JOB NO. 127-50N | DRG. NO. J2A

☐ NO EXCEPTIONS TAKEN ☐ REJECTED
☒ FURNISH AS CORRECTED
☐ REVISE AND RESUBMIT

PROJECT NO. IM-089-2(26) STATE BRIDGE NO. 50N
MATERIAL AASHTO M270 Gr 36 ELECTRODES: PER PROC HOLES: AS NOTED SHOP BOLTS:
SURFACE PREP. & PAINT:
GALVANIZED AFTER FAB

DESCRIPTION: EXP. JOINT-ABUT. 2
JOB: BRIDGE 50N
I 89 OVER U.S. ROUTE 2
MIDDLESEX-BOLTON VT
CUSTOMER: WINTERSET INC.

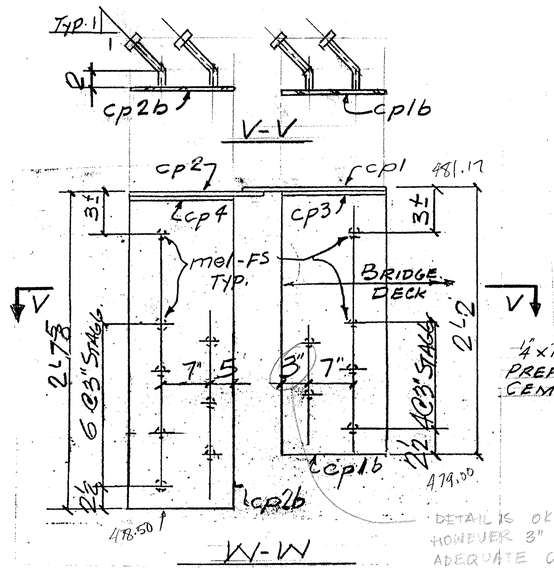
DETAIL IS OK @ SOUTH FACE HOWEVER 3" WILL NOT PROVIDE ADEQUATE COVER @ NORTH FACE
